BOLT, MACHINE – DOUBLE HEXAGON EXTENDED
WASHER HEAD, PD SHANK, NICKEL ALLOY,
UNS N07718, 185 KSI MIN, .4375-20 UNJF-3A

SAE AS3240
SHEET 1 OF 3

REV.
C

FIGURE 1 – BOLT

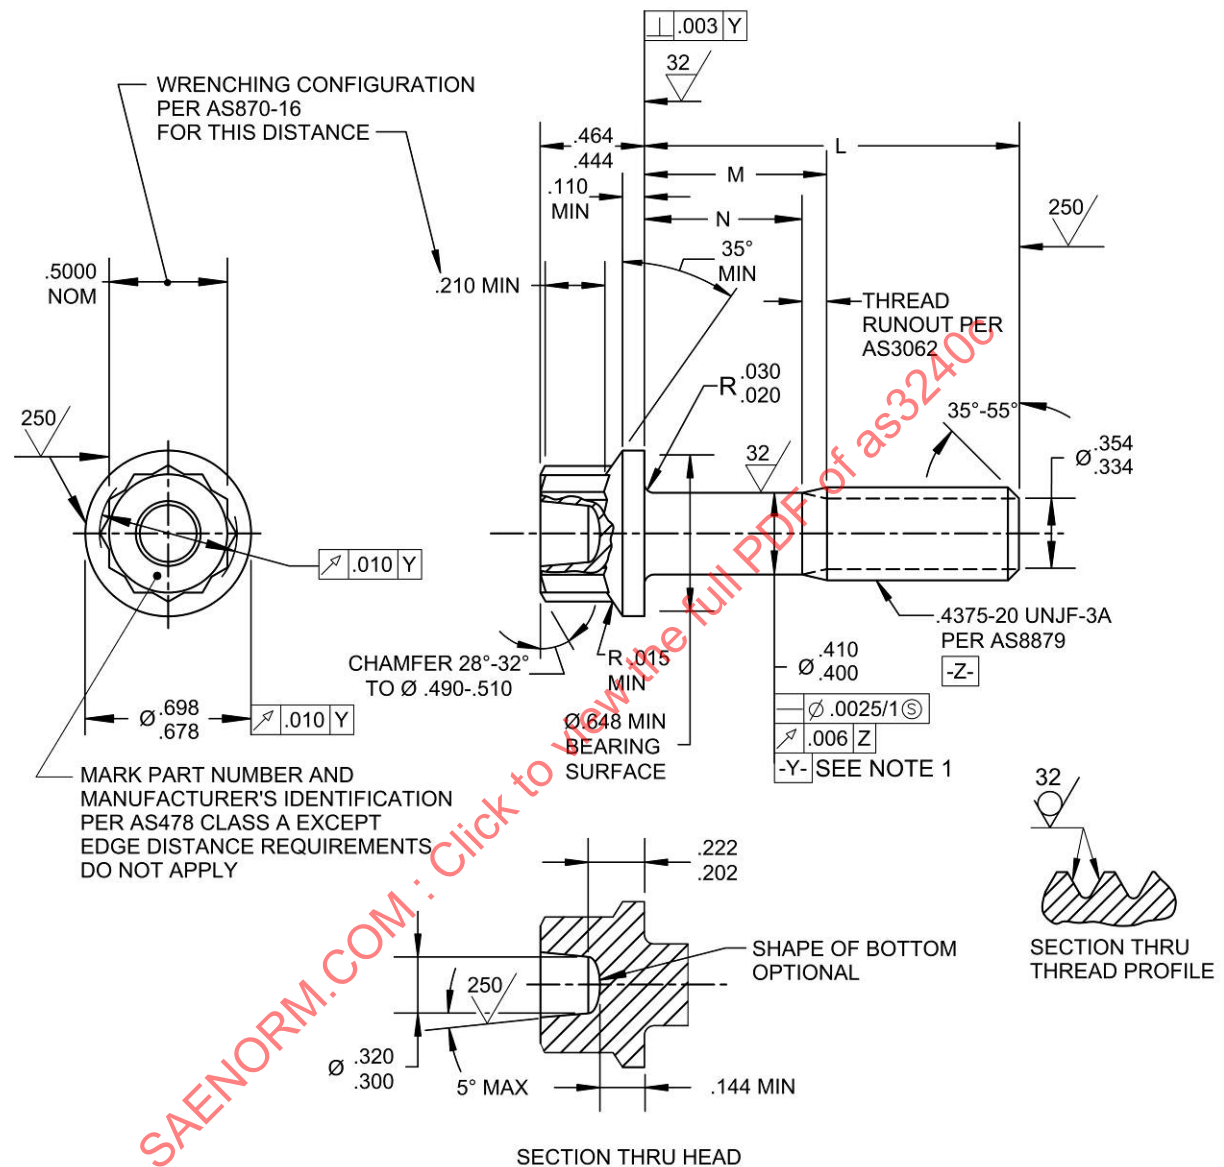
REVISE WRENCHING ELEMENT RUNOUT CALLOUT (RELOCATE FROM WRENCH FLATS TO POINTS). REVISE THREAD SPECIFICATION TO AS8879. REVISE LIGHTENING HOLE CONFIGURATION (ADD VIEW A) TO ALLOW OPTIONAL SHAPE AT BOTTOM OF HOLE.
